CITY OF ALBUQUERQUE

RE: 601 Winterwood SE

Grading and Drainage Plan Stamp Date: 2/10/20

Hydrology File: L23D032

| 60 |)1 WINTERWOOD PL. | , S |
|----|-------------------|-----|
| | GRADING PLAN | |

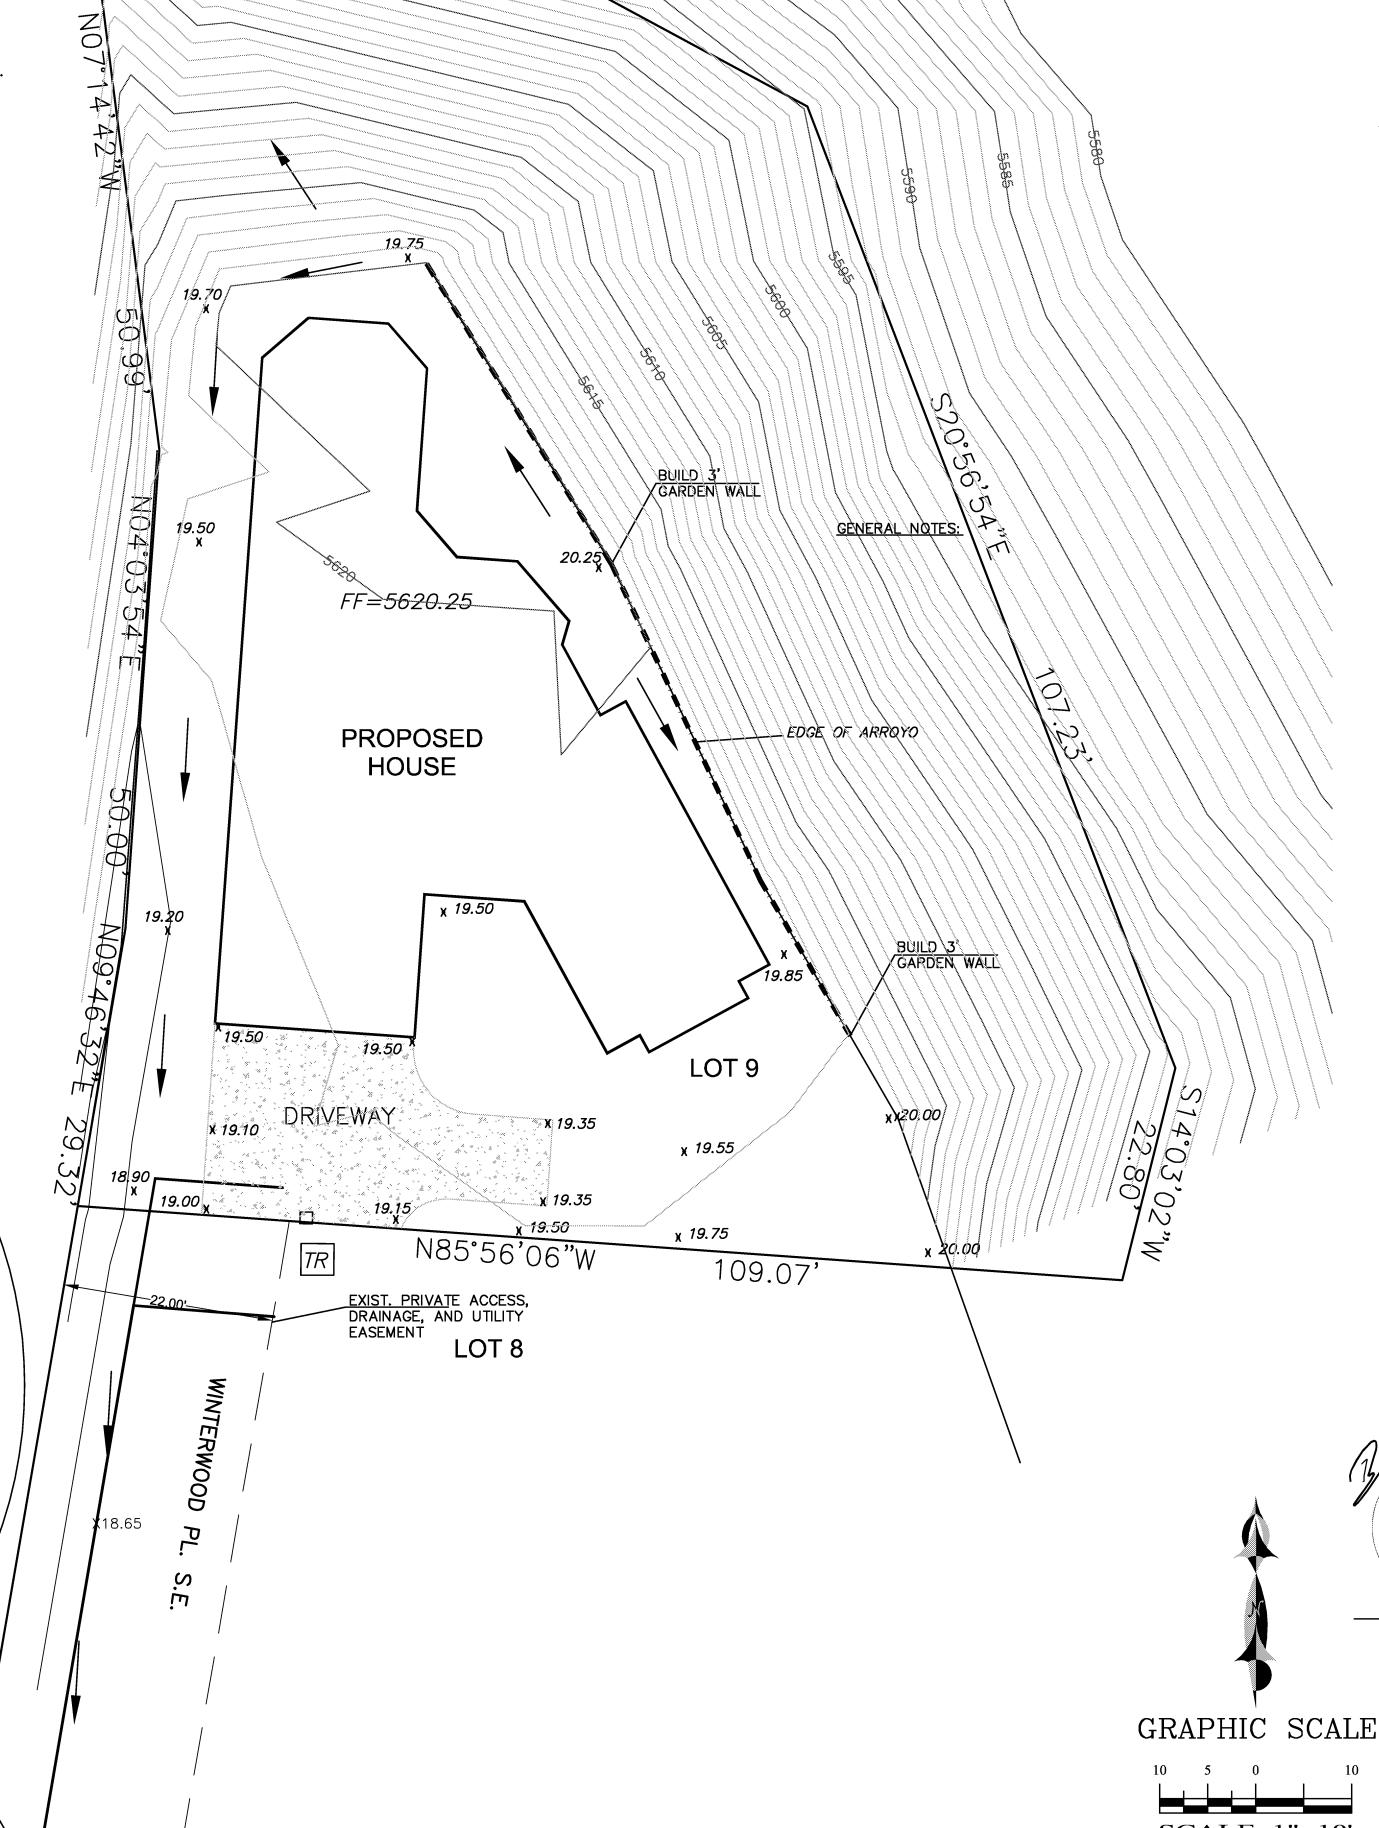
Based on the submittal received on 2/17/20, the grading plan is approved for Grading Permit.

1. Engineer's Certification of the compacted pad and grades at property line (Pad Certification), per the DPM Chapter 22.7: *Engineer's Certification Checklist For Non-Subdivision* is required.
